STERLING RANCH FILING NO. 2

FINAL PLAT
STERLING RANCH FILING NO. 2
JOB NO. 25188.01
01/21/2021
SHEET 1 OF 7

FILE NO. SF-20-015

plat V_2 planning only.pdf Markup Summary 3-26-2021

FINAL PLAT
STERLING RANCH FILING NO. 2
JOB NO. 25188.01
01/21/2021
SHEET 3 OF 7
FILE NO. SF-20-015

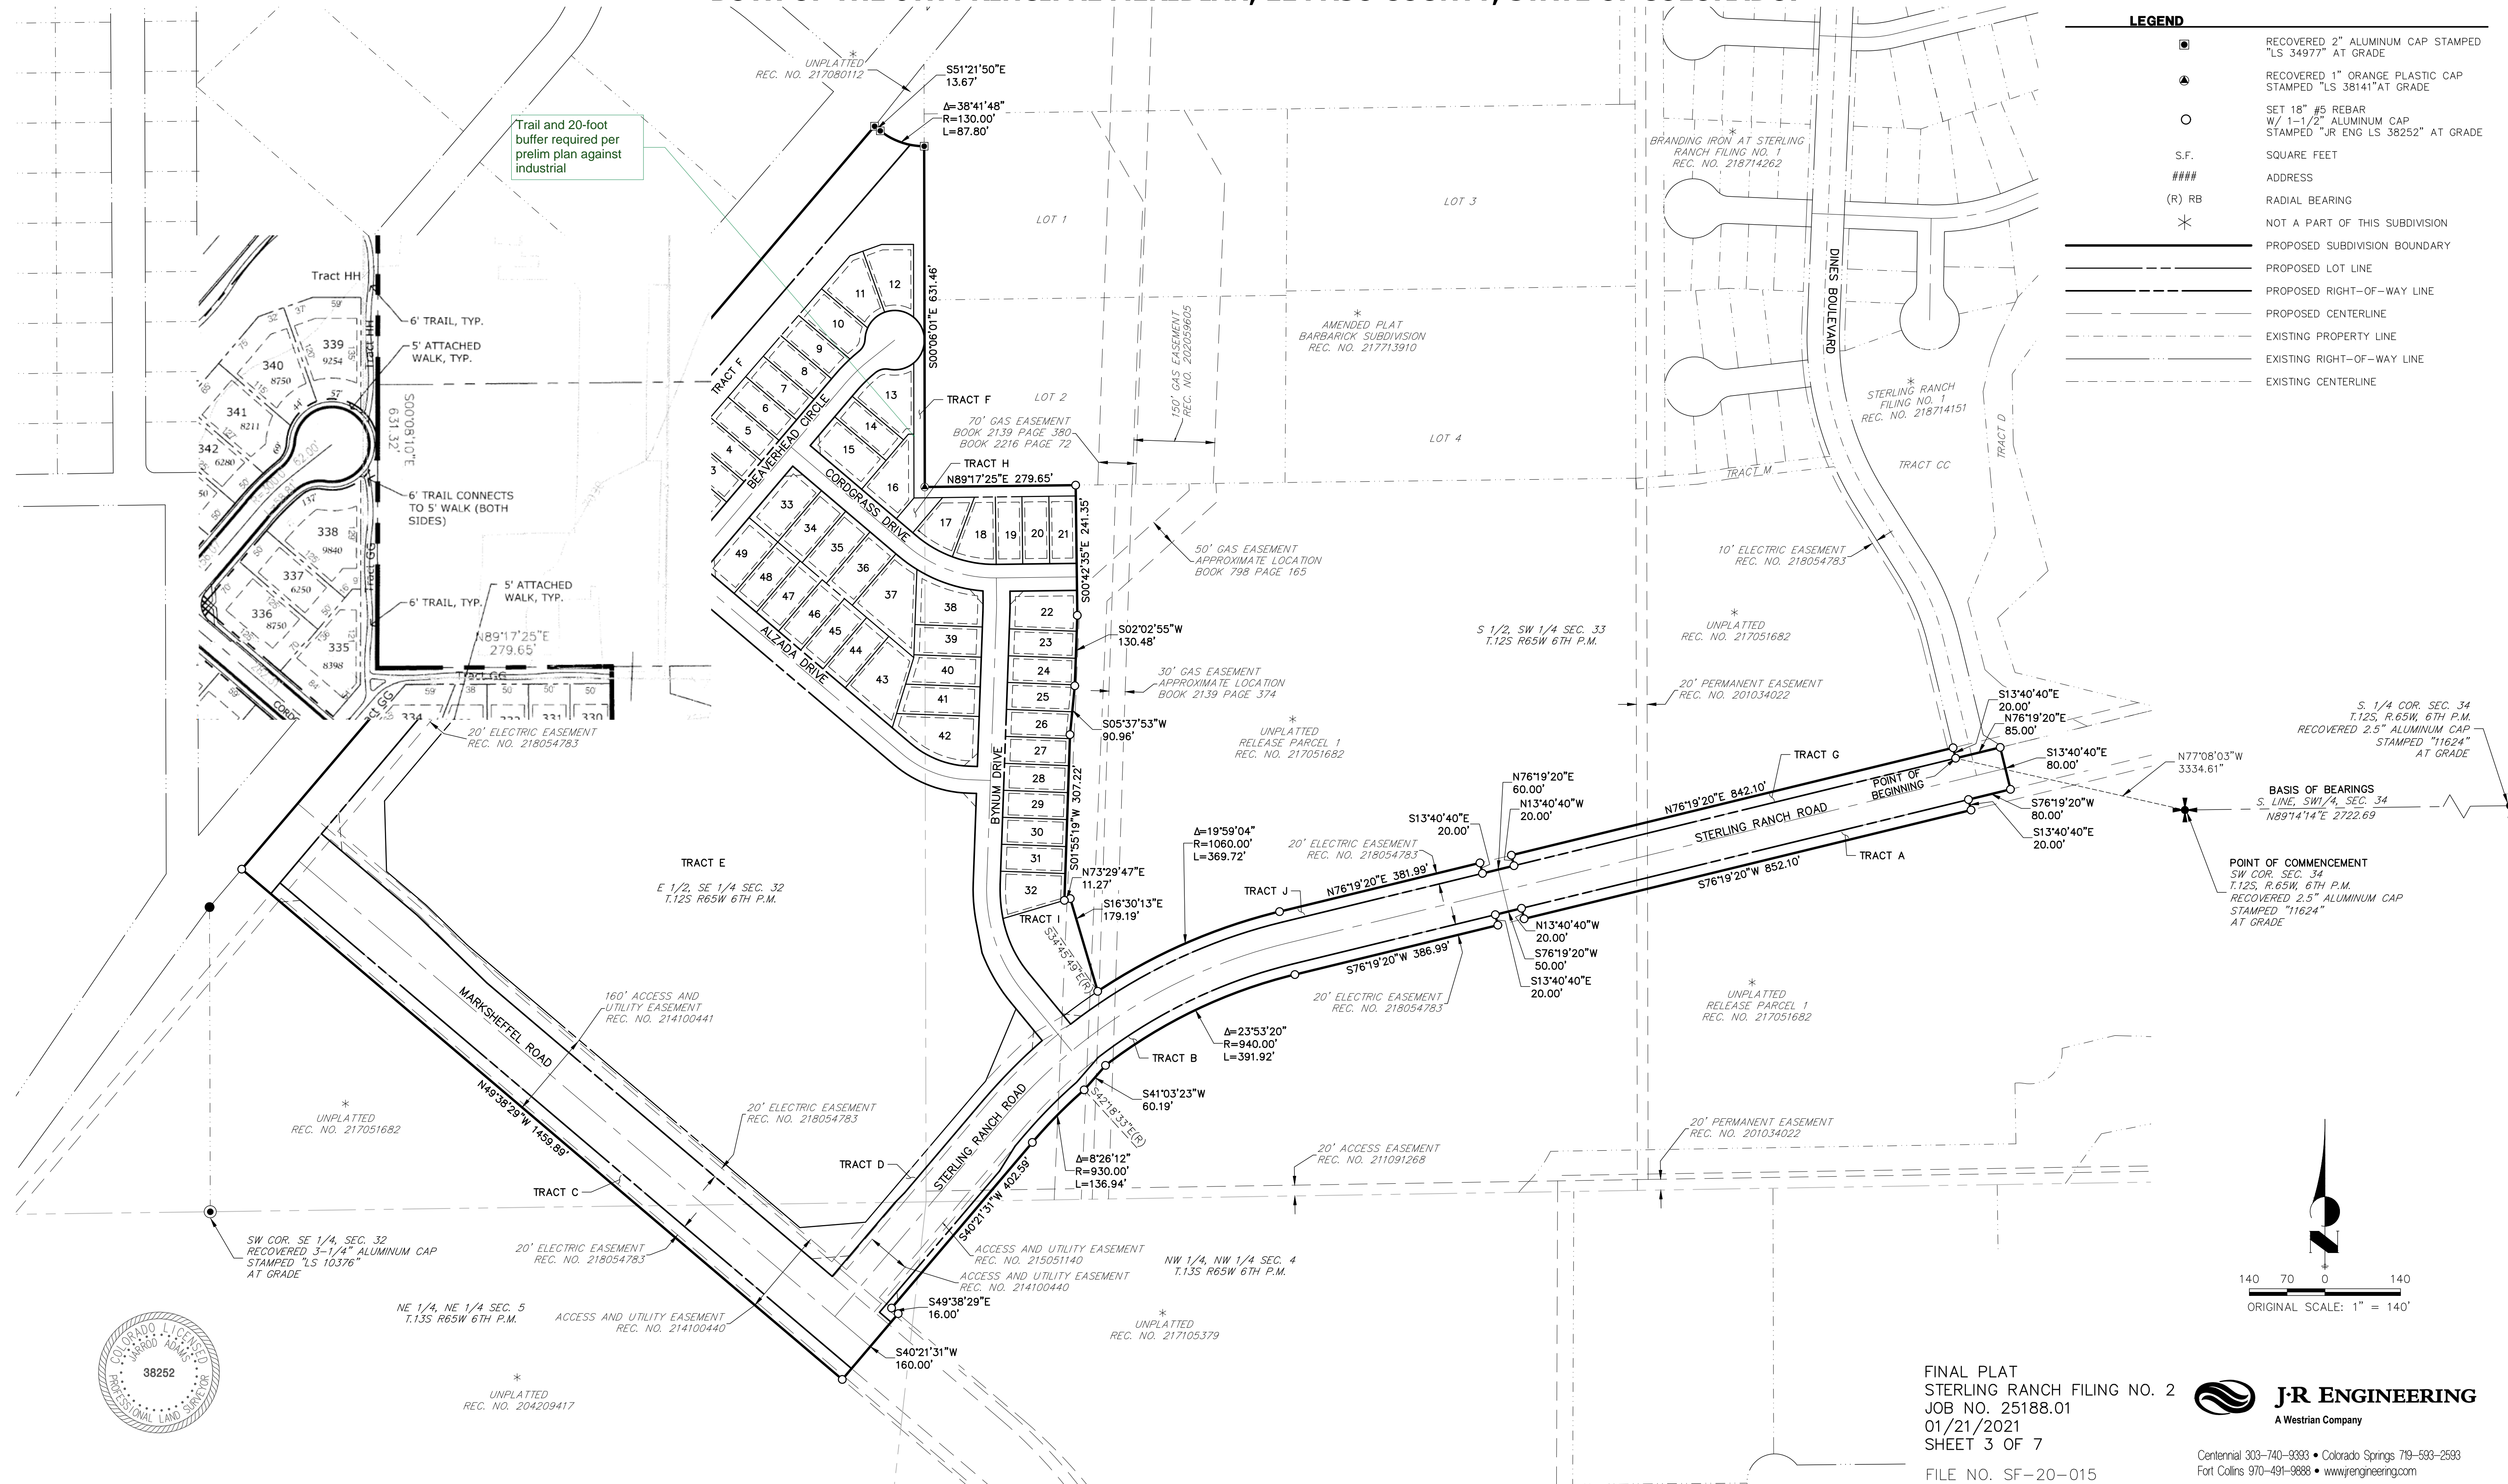
Trail and 20-foot
buffer required per
prelim plan against
industrial

Trail and 20-foot buffer required per prelim plan against industrial

FINAL PLAT
STERLING RANCH FILING NO. 2
JOB NO. 25188.01
01/21/2021
SHEET 4 OF 7
FILE NO. SF-20-015

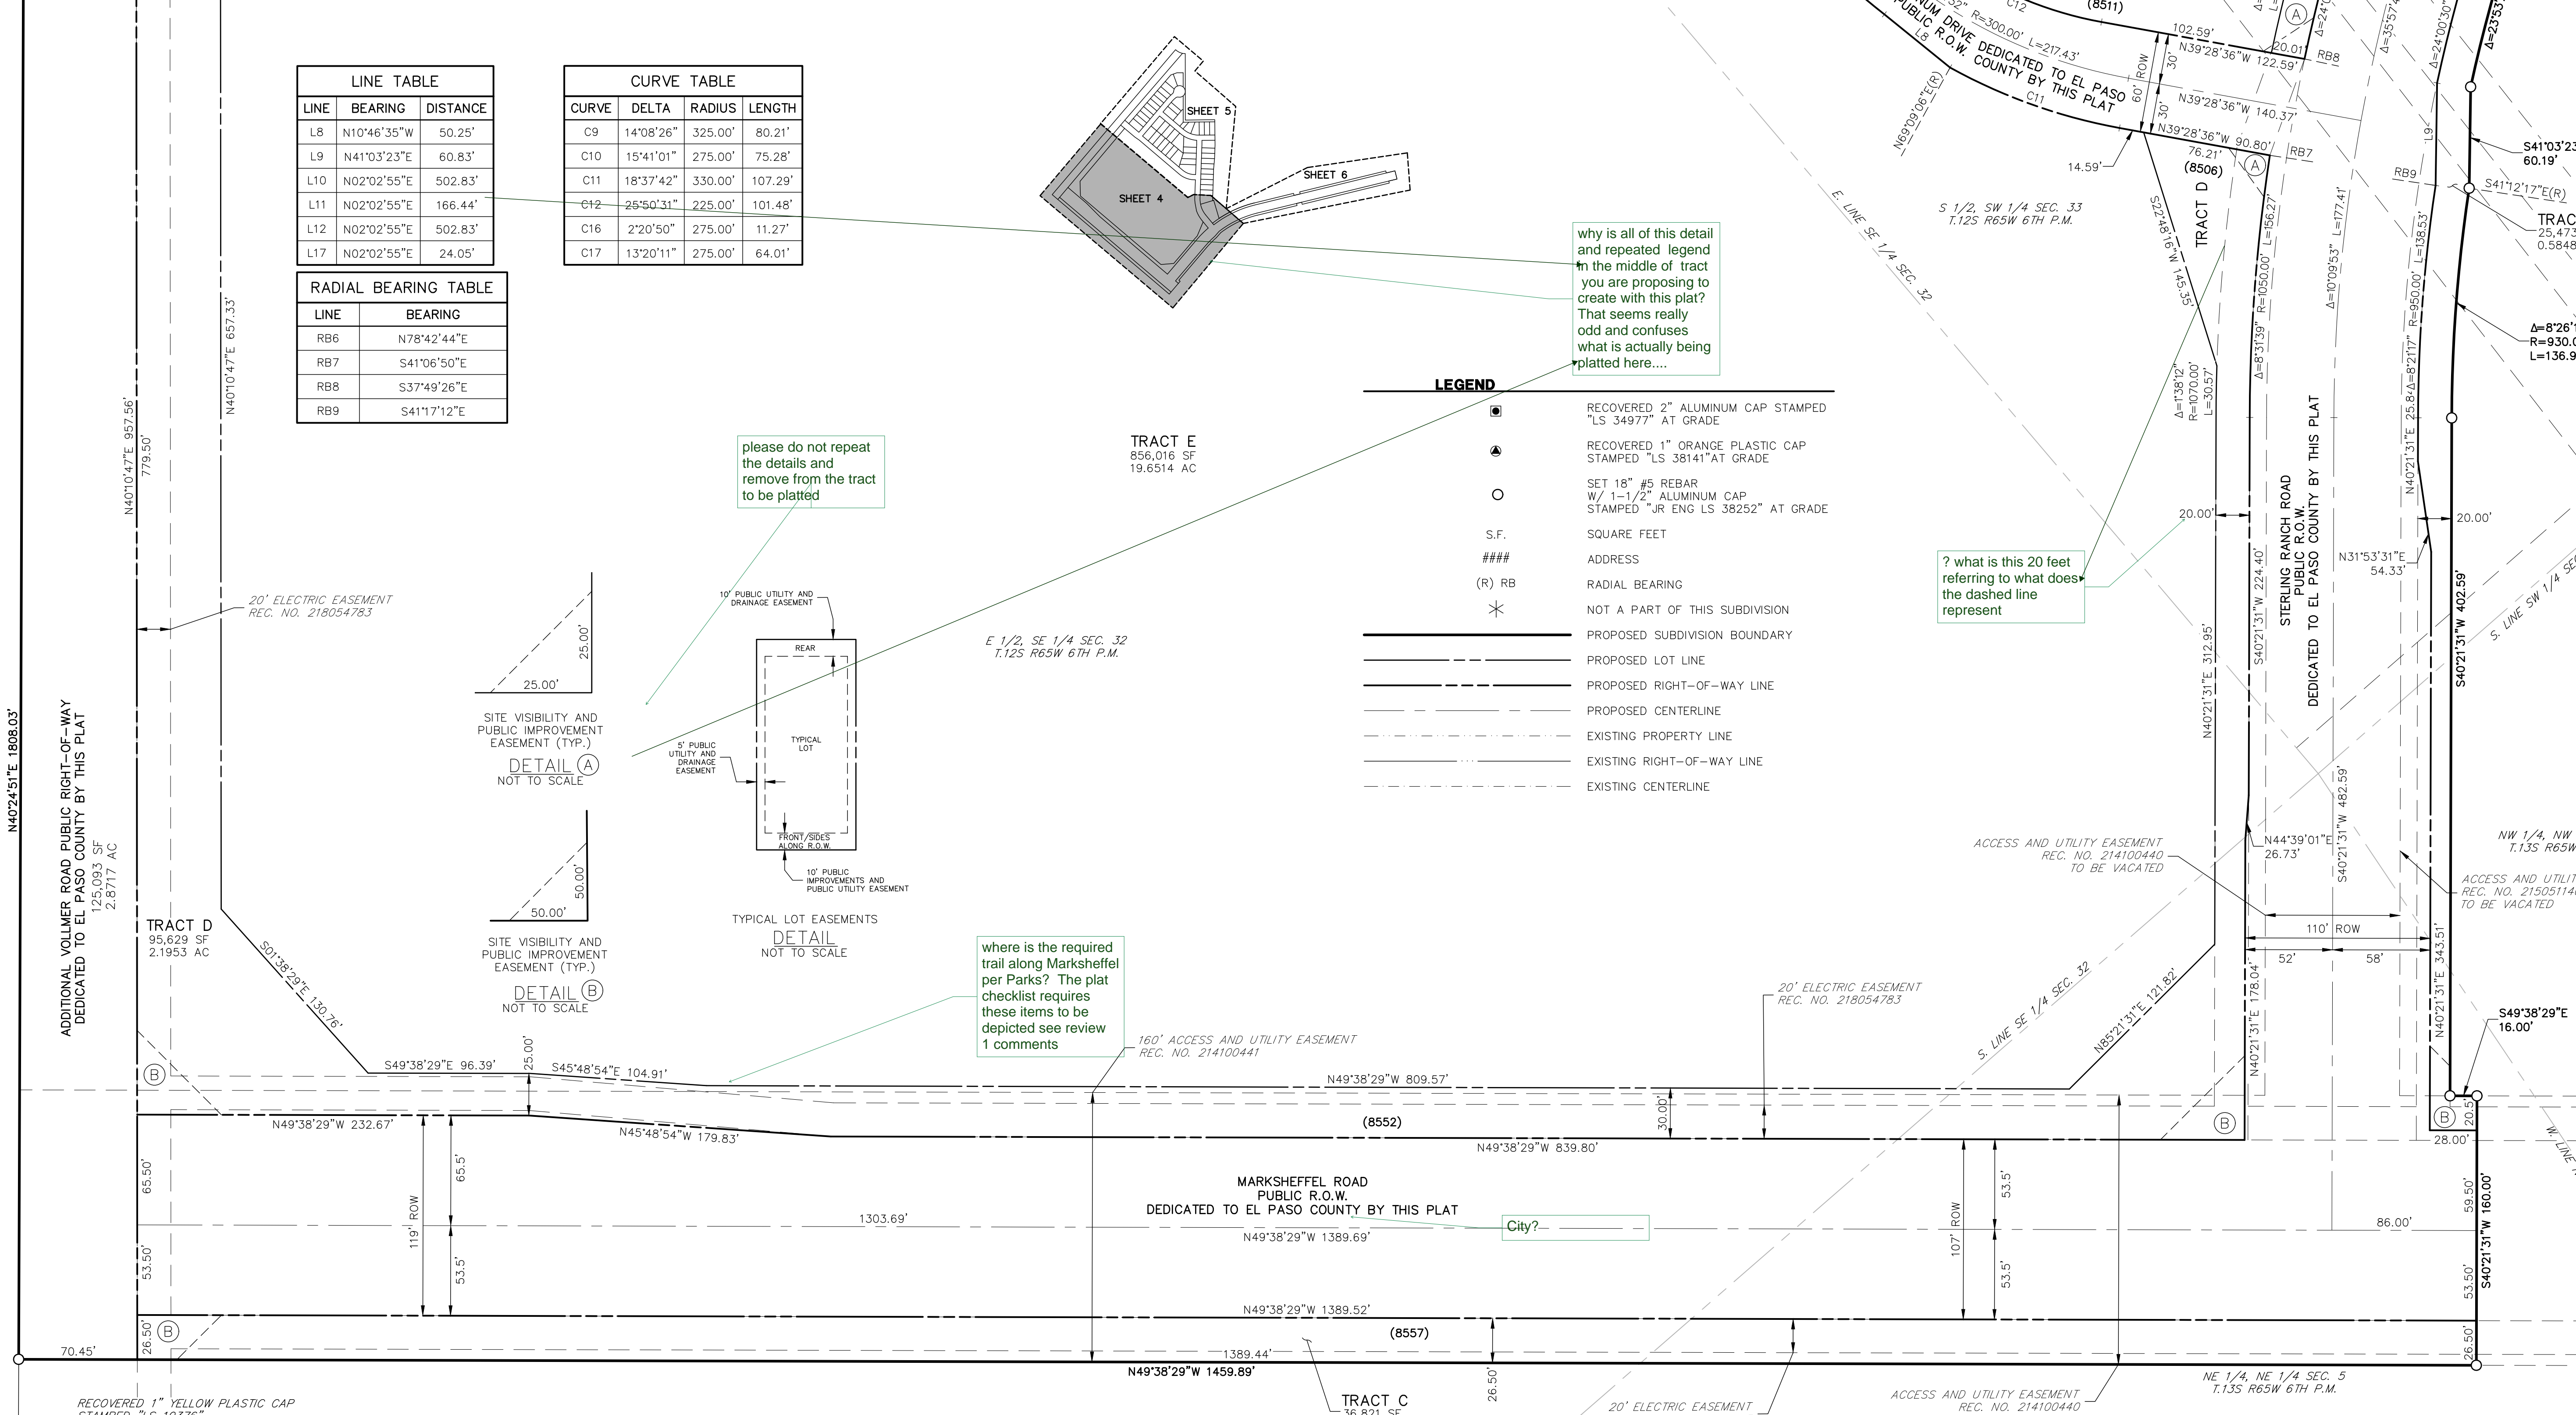
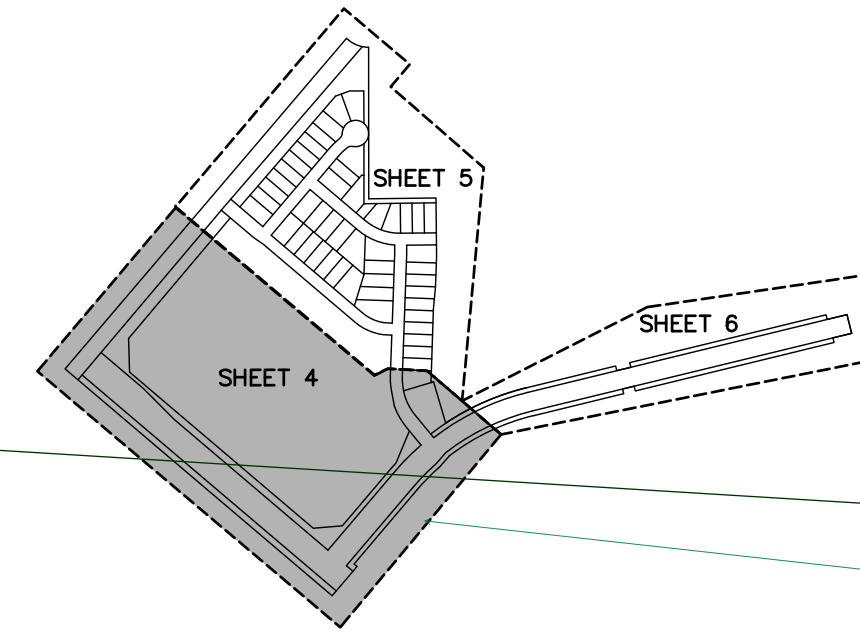
why is all of this detail and repeated legend in the middle of tract you are proposing to create with this plat? That seems really odd and confuses what is actually being platted here....

please do not repeat the details and remove from the tract to be platted

where is the required trail along Marksheffel per Parks? The plat checklist requires these items to be depicted see review 1 comments

? what is this 20 feet referring to what does the dashed line represent

why is all of this detail and repeated legend in the middle of tract you are proposing to create with this plat? That seems really odd and confuses what is actually being platted here....

where is the required trail along Marksheffel per Parks? The plat checklist requires these items to be depicted see review 1 comments

City?

? what is this 20 feet referring to what does the dashed line represent

please do not repeat the details and remove from the tract to be platted
